## ORIGINATION FORM

Proposed Revisions to a Standard Plans Index  
(Please provide all information — Incomplete forms will be returned)

Index Number: 715-002  
Sheet Number (s): 1  
Index Title: Conventional Lighting

Sheet 2: Clarified that lower luminaire mounting heights of 20' and 25' are for wildlife-sensitive only

INDEX	SHEET
715-002	2 of 8

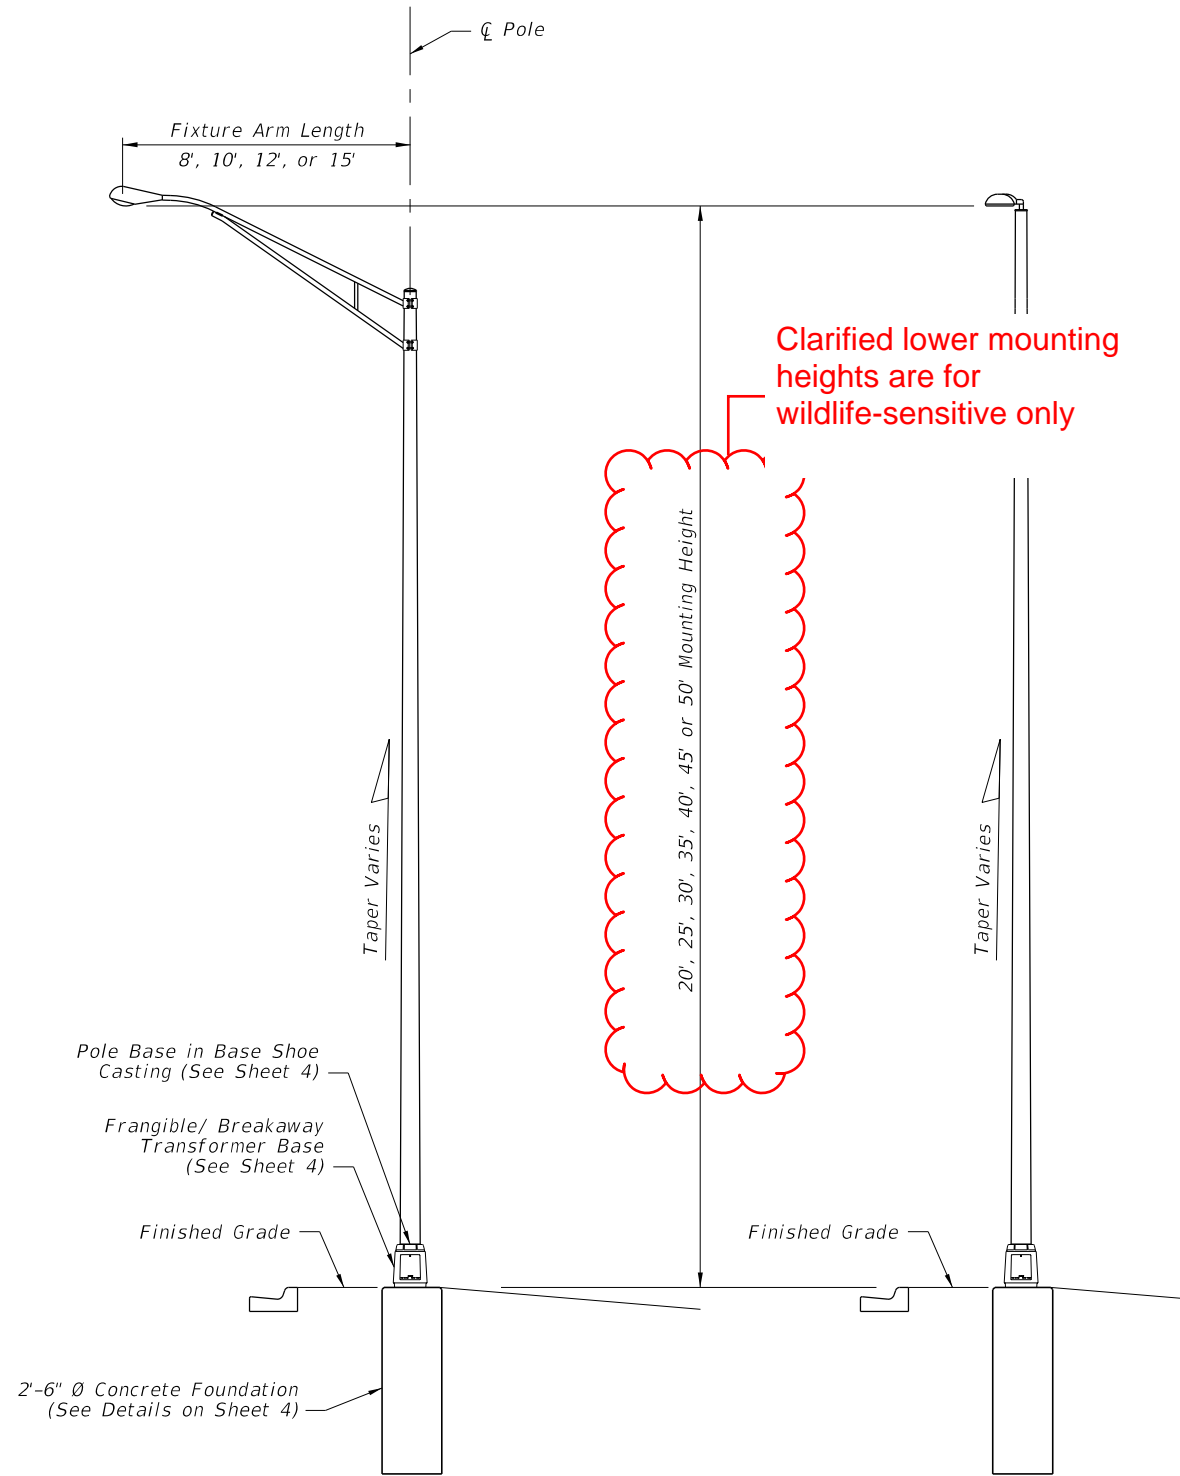
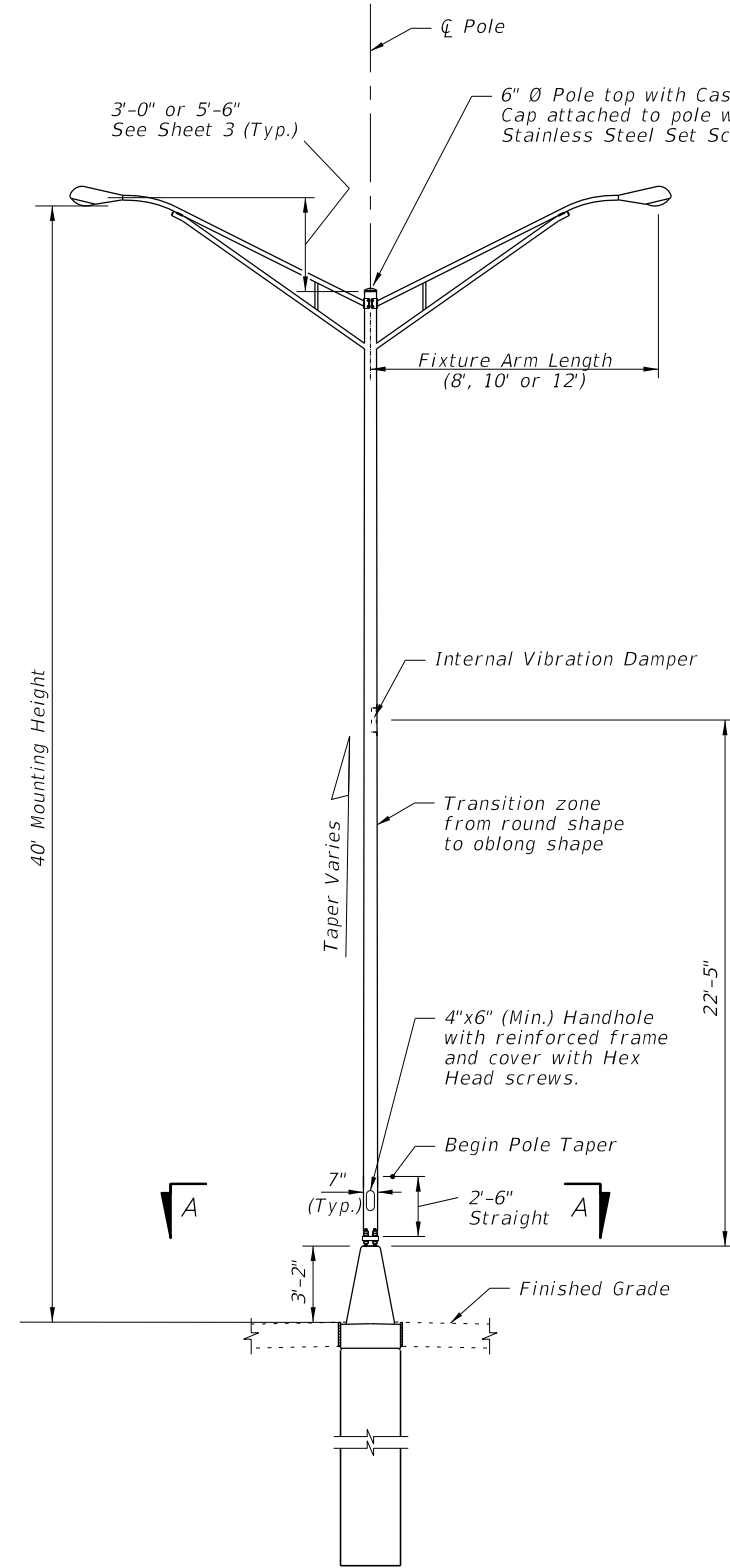
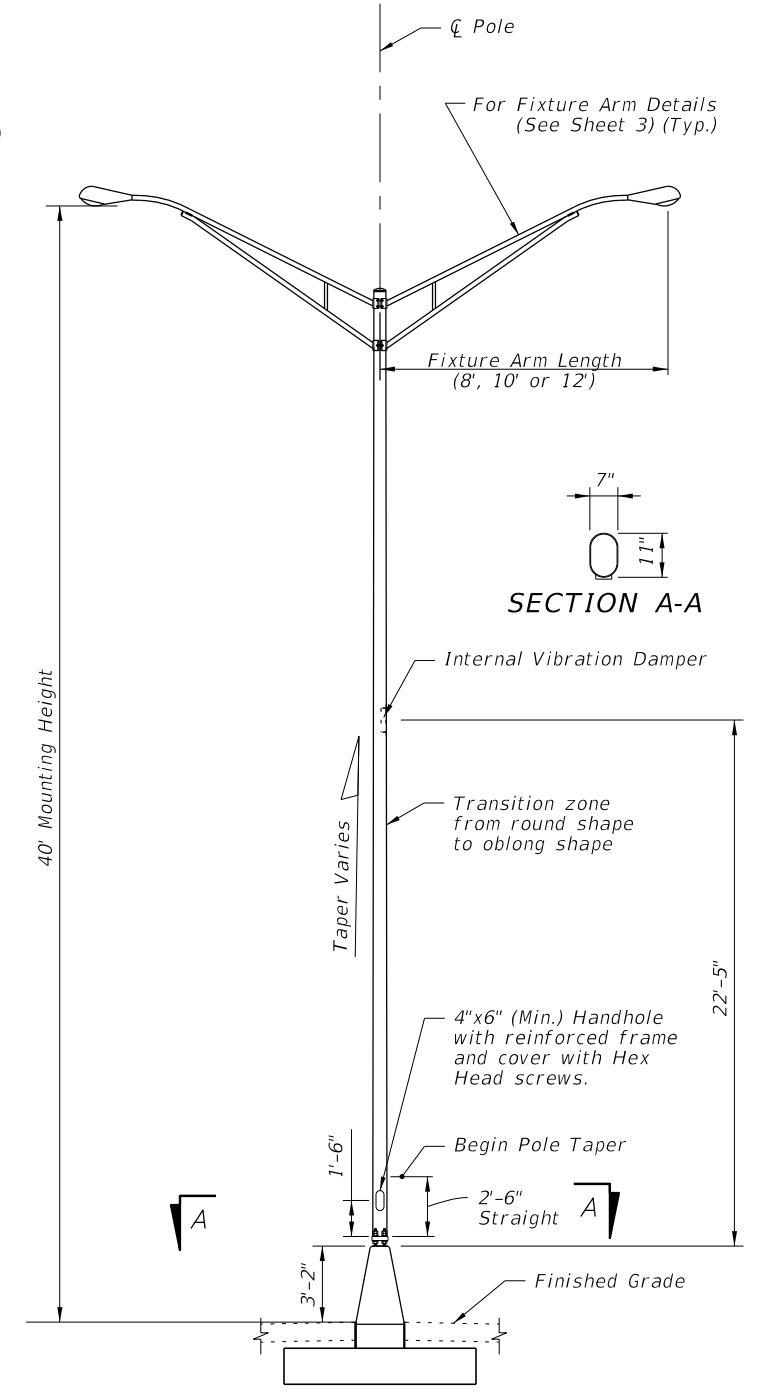
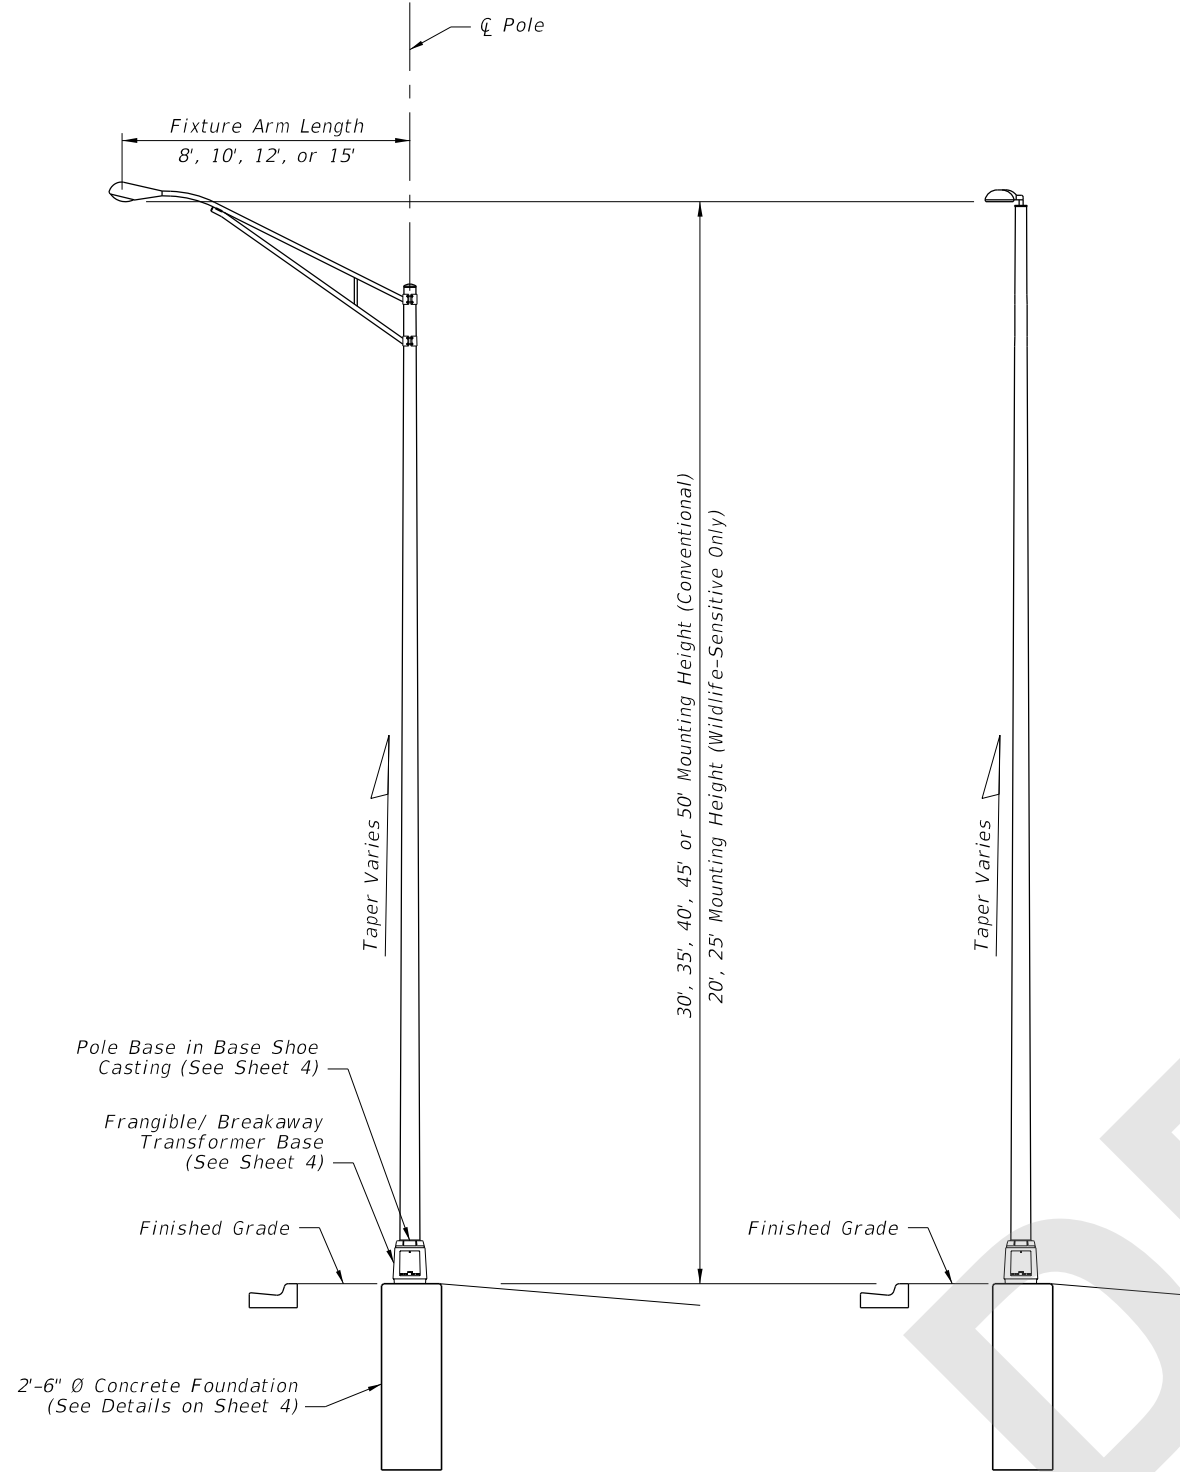
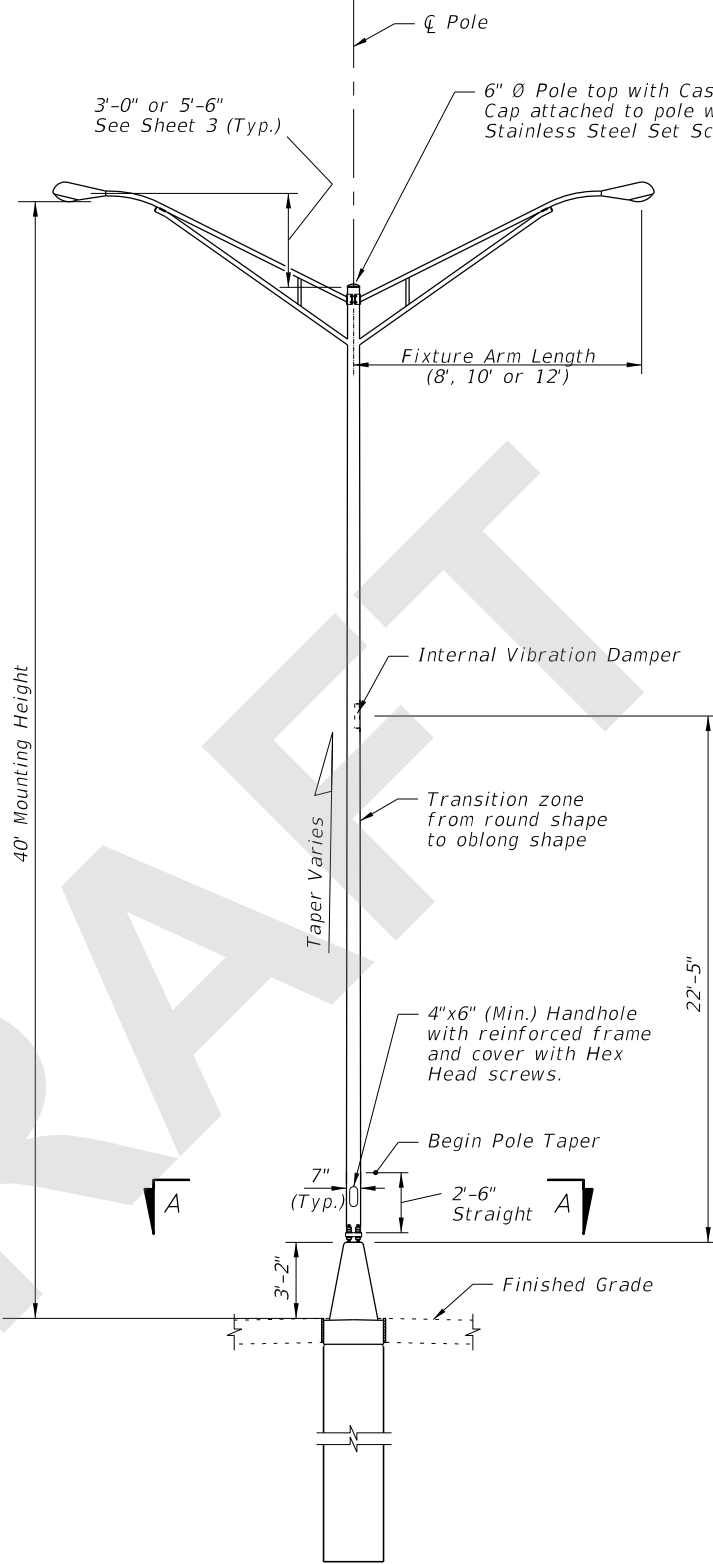
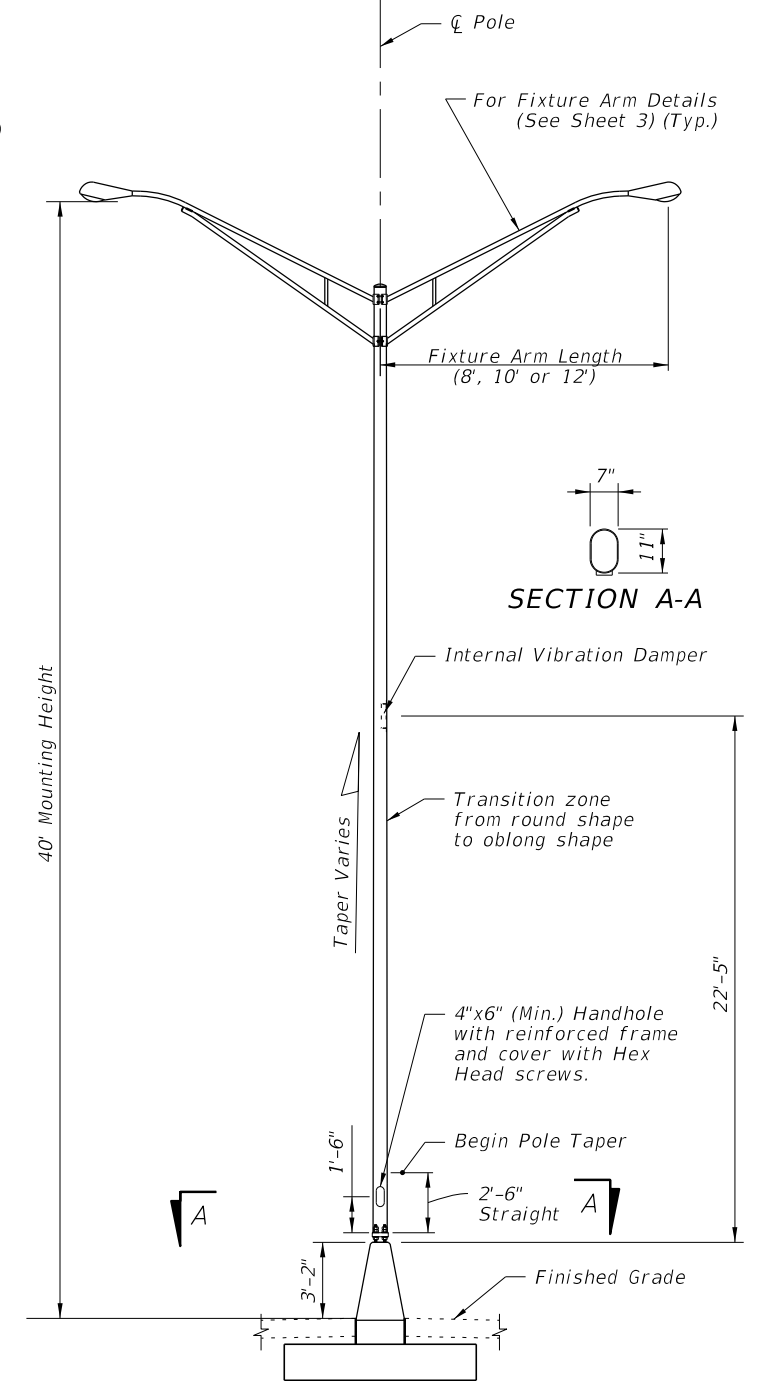
Clarification added due to consultant question on recently added mounting heights

Clarified lower mounting heights are for wildlife-sensitive only

20', 25', 30', 35', 40', 45' or 50' Mounting Height
